District 2
Certcode 1418-0

**CERTIFICATE OF HIGHWAY MILEAGE
YEAR ENDING FEBRUARY 10, 2026**

We, the members of the legislative body of **SPRINGFIELD** in **WINDSOR** County on an oath state that the mileage of highways, according to Vermont Statutes Annotated, Title 19, Section 305, added 1985, is as follows:

**Mileage Certificate Changes 2026
SPRINGFIELD TH-17**

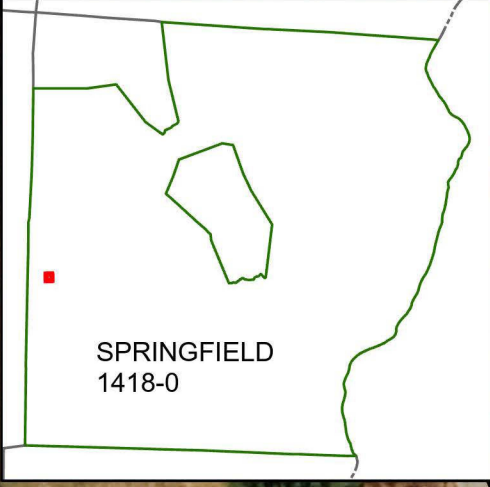
0.03 mi CL3 TH-17 designated Not Up to Standards (NUTS) pursuant to 19 VSA 305(a)

(CL3 TH-17 from 0.65 to 0.62 mi;
CL4 TH-17 from 0 to 0.03 mi)

Mileage Certificate Changes 2026
NORTH SPRINGFIELD U. C. TH-700 AND TH-708

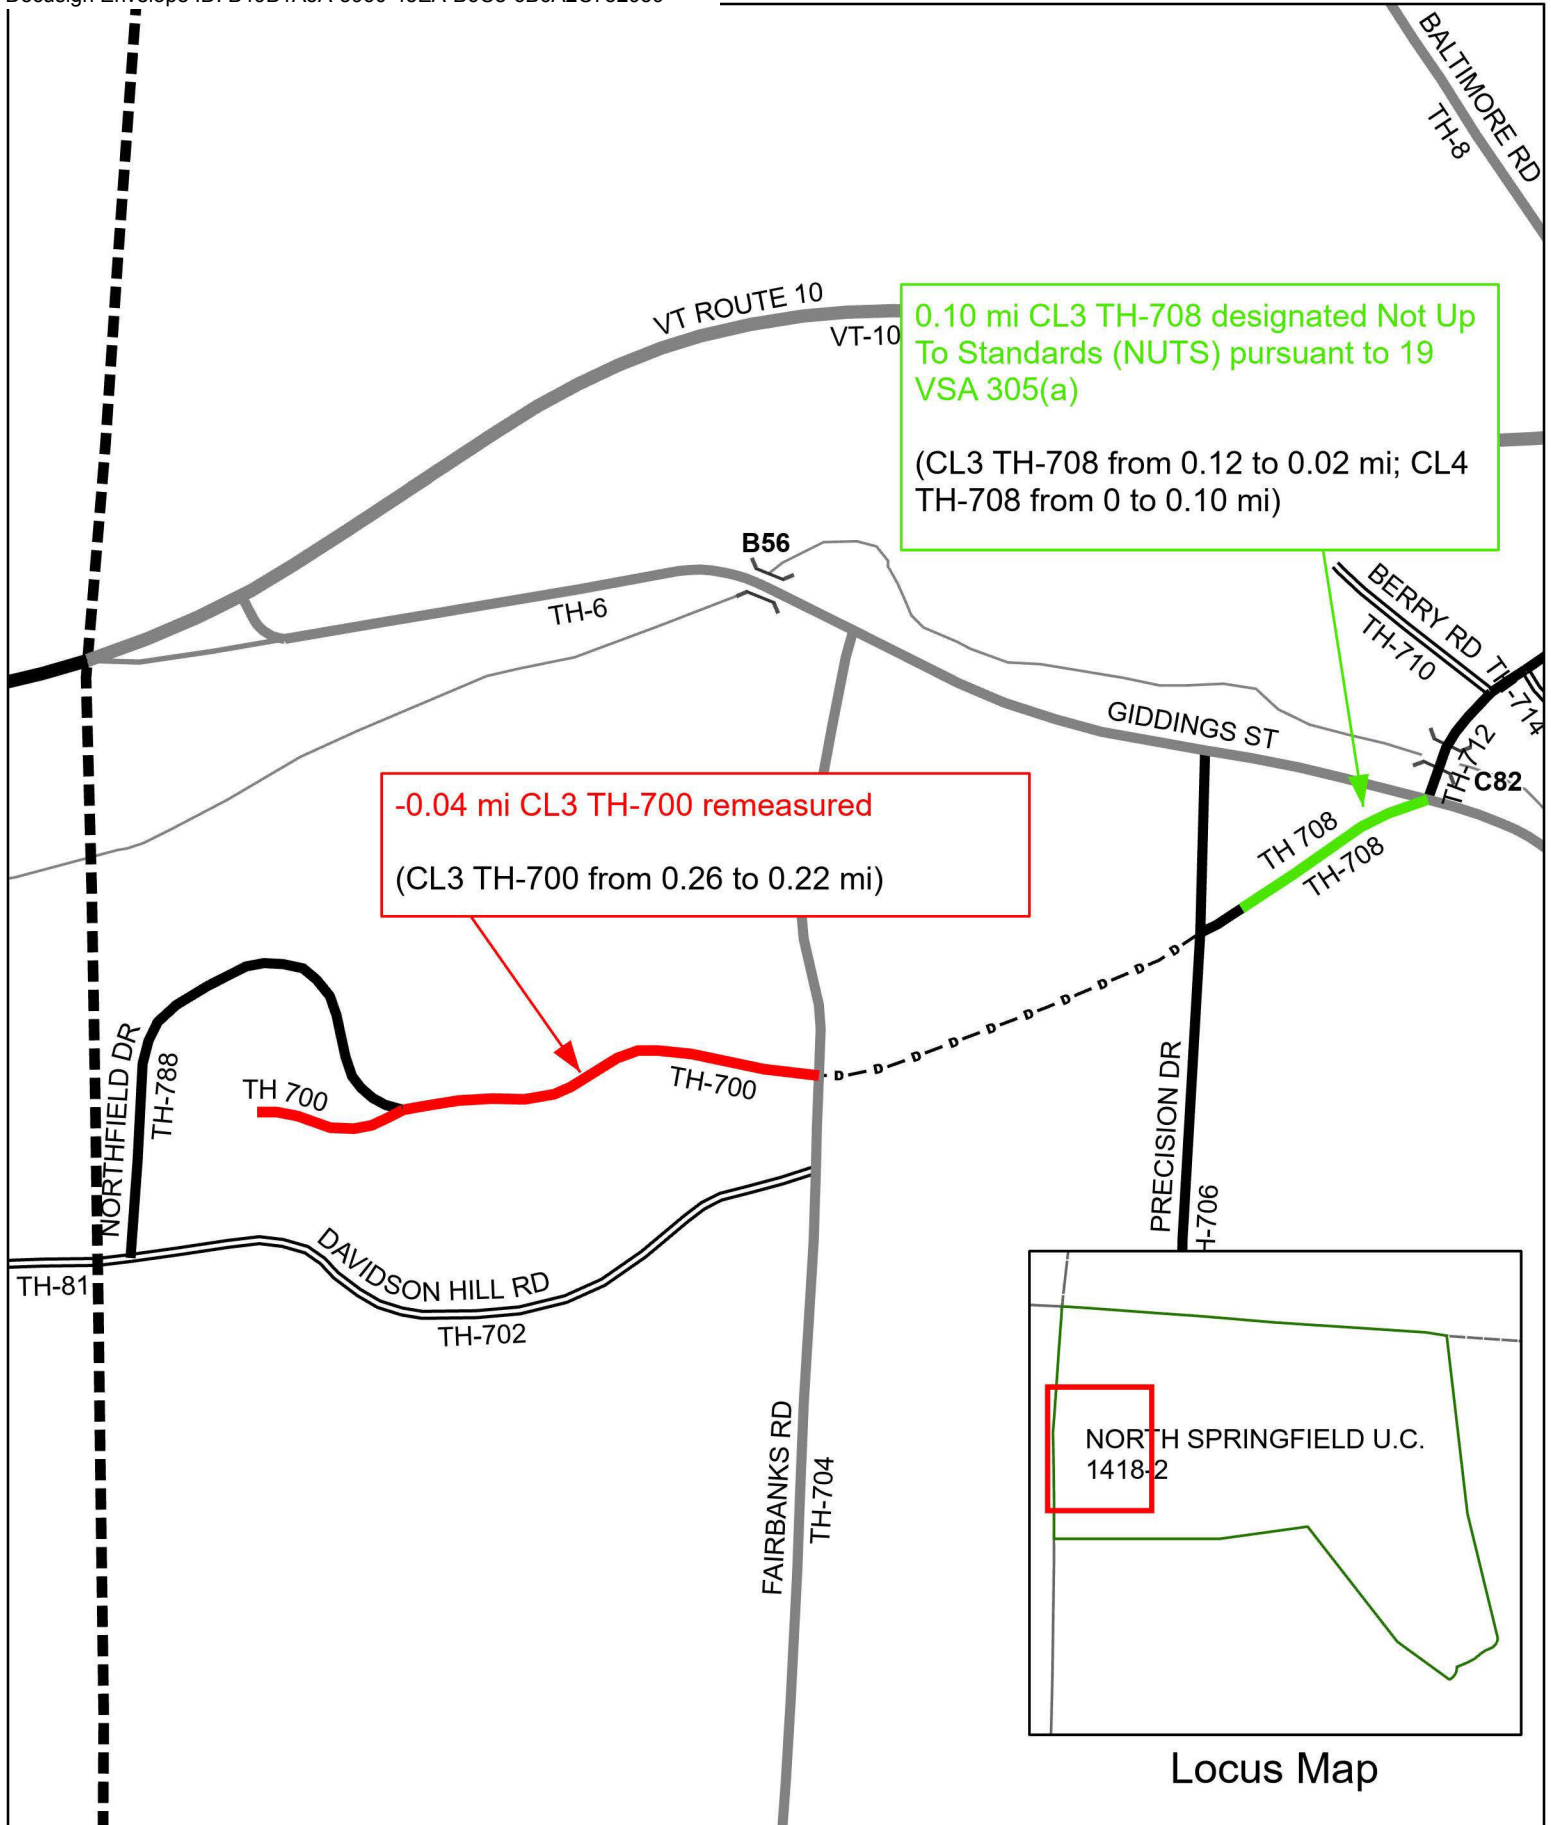
0.03 mi CL3 TH-17, 0.10 mi CL3 TH-708 and 0.04 mi CL3 TH-716 designated Not Up To Standards (NUTS) pursuant to 19 VSA 305(a); -0.04 mi CL3 TH-700 remeasured; +0.03 mi CL3 TH-317 (Hoover St) added previously unmapped approach and remeasured

Mileage Certificate Changes 2026
SPRINGFIELD U.C. TH-317

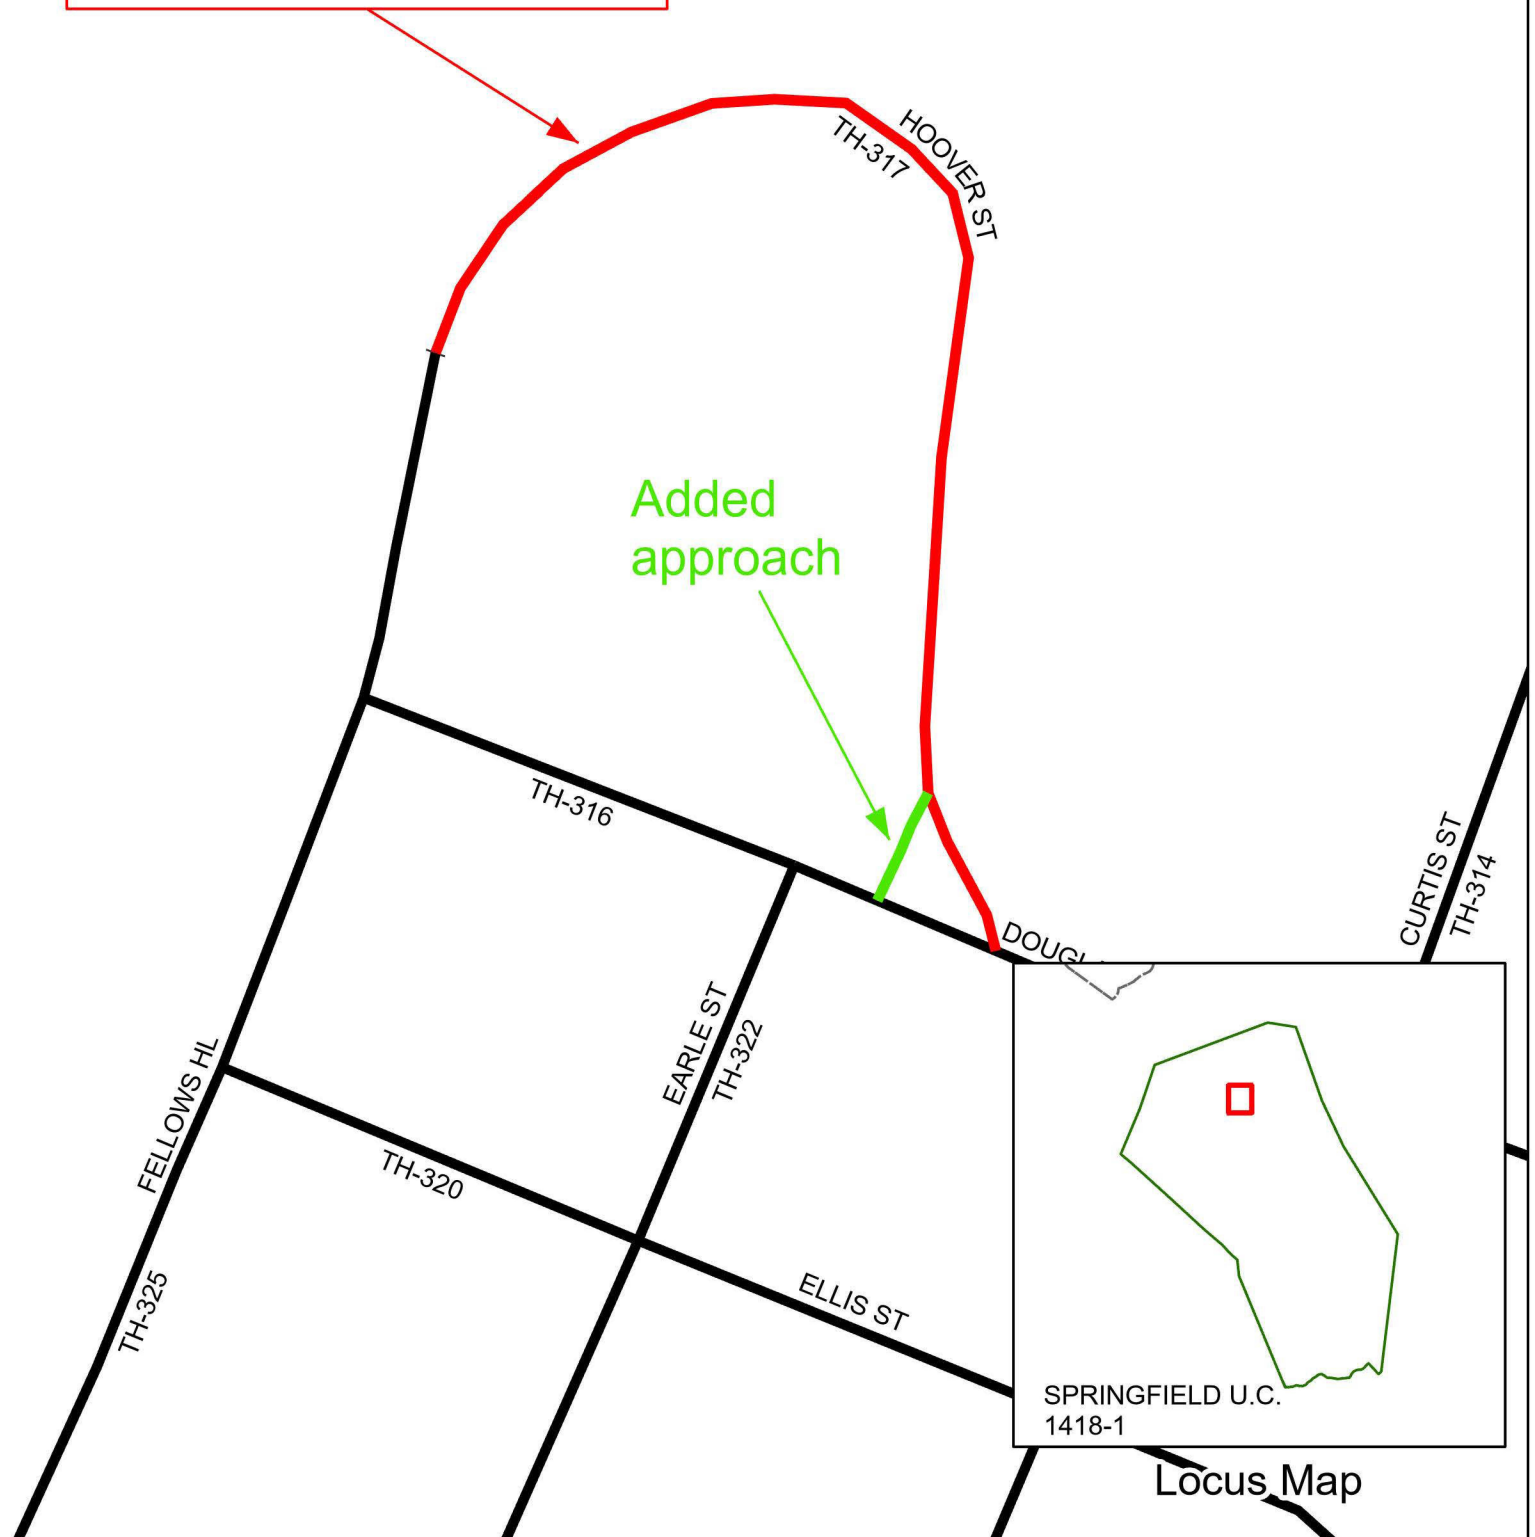
+0.03 mi CL3 TH-317 (Hoover St)
added previously unmapped approach
and remeasured

(CL3 TH-317 from 0.13 to 0.16 mi)

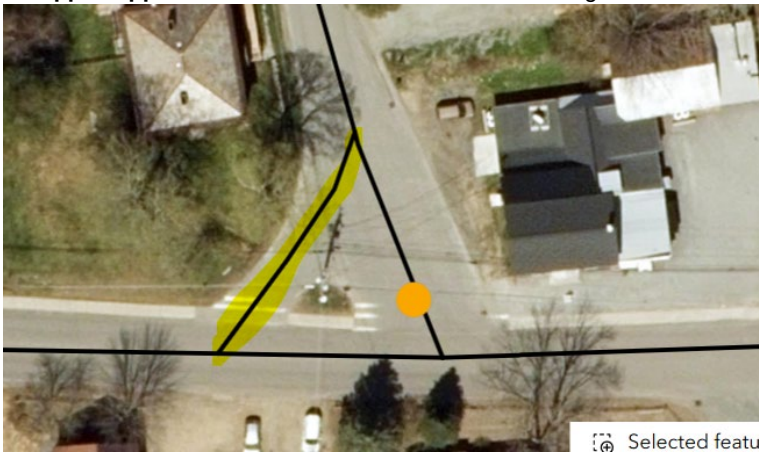
2. **TH-708** - It looks like this road is not maintained past a basketball court (see yellow highlight in image below and this link: [2 Precision Dr](#)), but it is classified as Class 3 with a total of 0.12 miles. Has the town discontinued past the basketball court and/or reclassified this road? If the Town has not discontinued or reclassified this, we will designate it as not up to Class 3 standards (NUTs) and the Town will either need to reclassify, discontinue or bring up to Class 3 standards within the next 5 years.

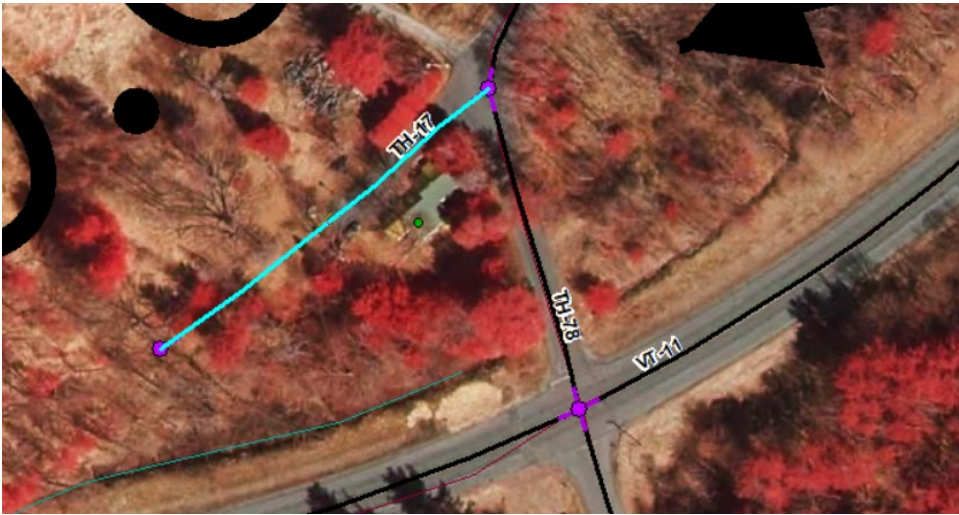
1. TH-700 (Northfield Dr.) – it looks like there may be another segment you may want to reclassify or discontinue. We have it mapped to continue past the intersection with TH-788 but it looks like it may be just a driveway now (see blue line image below). Here is the link to street maps that shows what the road looks like past the intersection. [Bing Maps - Directions, trip planning, traffic cameras & more](#). It look like it may be maintain but we just want to confirm it is still Town maintained. In 1992, we have a note from the inventory that the “cul-de-sac is gone”. If the Town does still maintain this segment, we would want to update the mileage since the cul-de-sac is gone. Let us know if the town what the status of this road is as well.
